# Access Compliance Report

## Public Rights-of-Way

### (Curb Ramps)

Intersection ID: 10023636	Main Street: CLOSEBURN_RD	Cross Street: N/A	Location: S
ADA ID: A81211D0CF49	Ramp Type: PerpDiag	Initial Pass/Fail: Fail	Overall Compliance: No
		Severity Score: 60

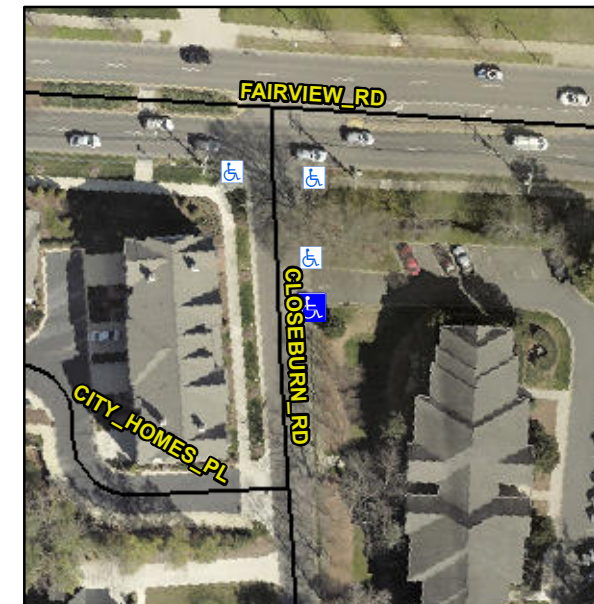
**Not Found, R304.5.1, R304.5.3**

Compliance	Description	Data	Compliance	Description	Data
N/A	Ramp Length (in)	58.0	Yes	Ramp Slope (%)	8.0
No	Ramp Width (in)	25.0	No	Ramp XSlope (%)	7.3
N/A	Flare Type LT	N/A	N/A	Flare Type RT	N/A
N/A	Flare Slope LT (%)	N/A	N/A	Flare Slope RT (%)	N/A
N/A	Flare Traversable LT?	N/A	N/A	Flare Traversable RT?	N/A
N/A	Landing Length (in)	N/A	N/A	DWS Provided?	N/A
N/A	Landing Width (in)	N/A	N/A	DWS Contrast?	N/A
N/A	Landing Slope (%)	N/A	N/A	DWS Length (in)	N/A
N/A	Landing X Slope (%)	N/A	N/A	DWS Full Width?	N/A
N/A	Landing Curb? (Y/N)	N/A	N/A	DWS Offset (in)	N/A
N/A	Shared Landing?	N/A			
N/A	Gutter Ponding?	N/A	N/A	Gutter Slope (%)	N/A
N/A	Gutter Lip Ht (in)	N/A	N/A	Gutter X Slope (%)	N/A
N/A	Painted X Walk1?	No	N/A	Painted X Walk2?	No
	X Walk 1 Direction	To N		X Walk 2 Direction	To W
N/A	X Walk 1 Width (in)	N/A	N/A	X Walk 2 Width (in)	N/A
	X Walk 1 Slope (%)	2.5		X Walk 2 Slope (%)	0.1
	X Walk 1 X Slope (%)	9.0		X Walk 2 X Slope (%)	0.7

**Remove & Replace Curb Ramp With Two New Directional Ramps or Equivalent.**
